Service Bulletin  
DSB-04262010

Re: Recommended Wiring Change to HVAC Units with the following serial numbers only: G1D-10002 thru G1D-10006, G1D-10011 thru G1D-10013, G1D-10016 and G1D-10017.

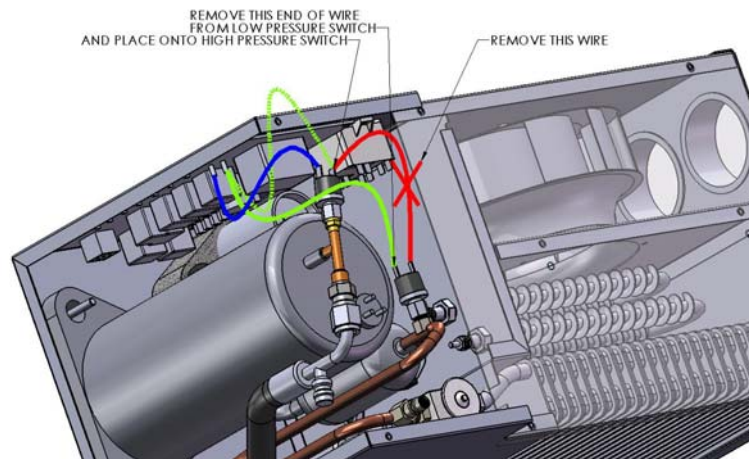
A wiring change is being implemented to all current HVAC units in the field to prevent possible short cycling of the AC compressor in cold ambient conditions.

1. Remove the Phillips head screws from compressor cover on the HVAC box and remove the cover.
2. Remove jumper wire between high pressure and low pressure switch. Discard this wire. (NOTE: The high pressure switch is the switch that is located closest to the PCB.)
3. On the other side of the low pressure switch remove the wire that runs to the PCB.
4. Take the wire that was removed in step 3 and connect one end to the open terminal of the high pressure switch and the other end to the open terminal on the PCB. (This procedure will remove the low pressure switch from the circuit.)
5. Reinstall the cover and screws.
